Note

Since September 1981 a preglow time relay with modified ventilation is installed for quick-start preglow system. The part number has not been changed.

Modified preglow time relay

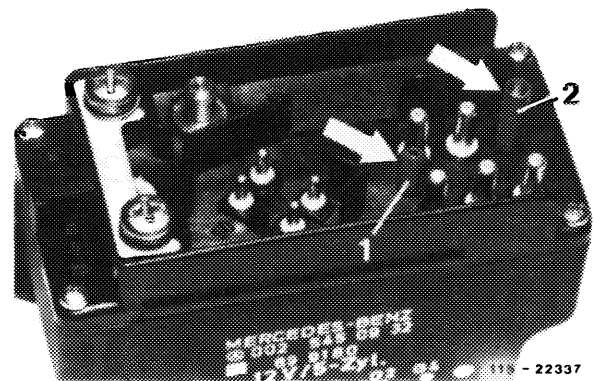
In the modified version of the preglow time relay, ventilation proceeds via coding pin (1). The coding pin (2) is also longer as before and the 5-pole coupler has been designed in such a manner that the ventilation is covered. In the former preglow time relay ventilation proceeded through a bore in housing.

- 1 Ventilation
- 2 Higher coding pin

The modified preglow time relay can also be installed in vehicles prior to September 1981. In such a case, the modified 5-pole coupler must also be installed, since otherwise moisture may enter the relay.

5-pole coupler

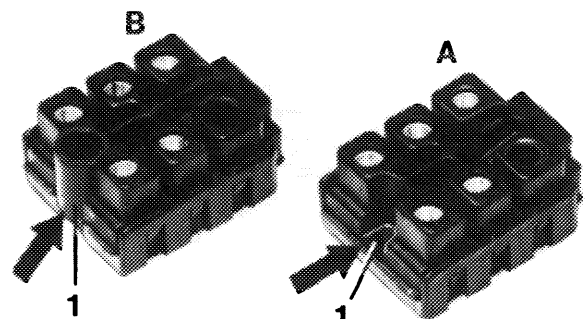
- A 1st version
- B 2nd version

Upon installation of the new relay, convert coupler of harness to new ventilation.
